DSP-14009

Application	General Data	
Project Name: Steeplechase Business Park, Parcels 58 and 59 (Advance Auto/Sonic) Location: On the northeast side of Walker Mill Road, approximately 400 feet west of its intersection with Hampton Park Boulevard. Applicant/Address: Atapco Properties, Inc. One South Street, Suite 2800 Baltimore, MD 21202	Planning Board Hearing Date:	12/18/14
	Staff Report Date:	12/02/14
	Date Accepted:	10/15/14
	Planning Board Action Limit:	12/24/14
	Plan Acreage:	2.0
	Zone:	I-1
	Dwelling Units:	N/A
	Gross Floor Area:	9,175 sq. ft.
	Planning Area:	75A
	Council District:	06
	Election District:	13
	Municipality:	N/A
200-Scale Base Map:	202SE08

STAFF REPORT

SUBJECT: Detailed Site Plan DSP-14009
Steeplechase Business Park, Parcels 58 and 59

SIGNAGE DETAILS

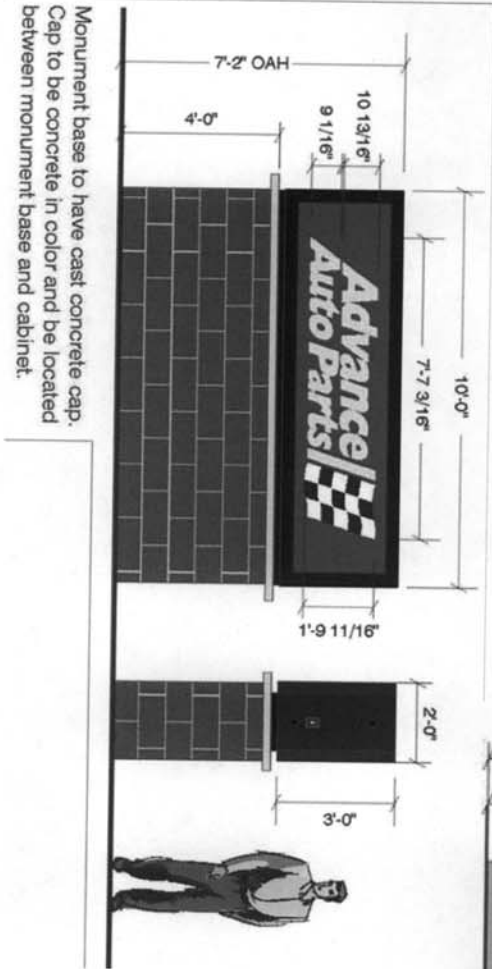
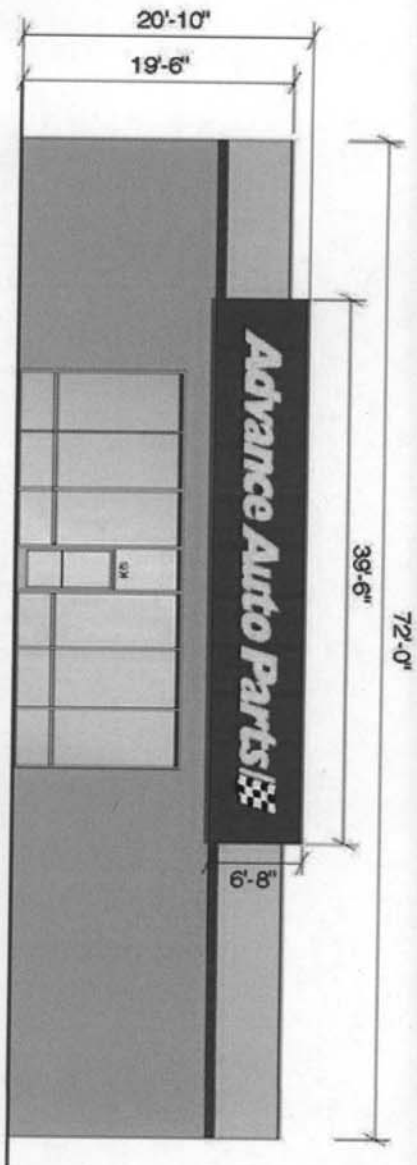
- c. The signage within the DSP has been reviewed for conformance with Section 27-613, which governs signs attached to a building or canopy. The submitted plans provide dimensions for the proposed building-mounted signage which indicate that the square footage for Advance Auto Parts exceeds the allowed standards. The entire sign area should be calculated for the total square footage provided. The sign area must either be reduced or a departure must be obtained.

The signage within the DSP has also been reviewed for conformance with Section 27-614, which governs freestanding commercial signs. The submitted plans propose two freestanding monument signs located along Walker Mill Road outside of the public utility easement, one each for Advance Auto Parts and the Sonic fast-food restaurant. It appears that the freestanding monument sign for Advance Auto Parts exceeds the allowable standards. As it is currently proposed, the entire sign face and brick base must be calculated into the total square footage. The base must be differentiated from the sign face if it is not to be included in the sign calculation. Either the signage must be reduced to fall within the allowable standards or be modified so the base is differentiated from the sign face, or a departure must be obtained.

- (17) The monument sign for Advance Auto Parts shall either be reduced in compliance with Section 27-614 of the Zoning Ordinance, or the sign base shall be modified so it is differentiated from the sign face and thereby excluded from the total sign area calculation, or the applicant shall obtain a departure from sign design standards.

- (1) Indicate the monument sign setbacks from the right-of-way.
 - (2) Provide a chart for the freestanding and building-mounted signage showing the regulations in Sections 27-613 and 27-614 of the Zoning Ordinance being met. Calculations for what is permitted and what is being provided shall be included.
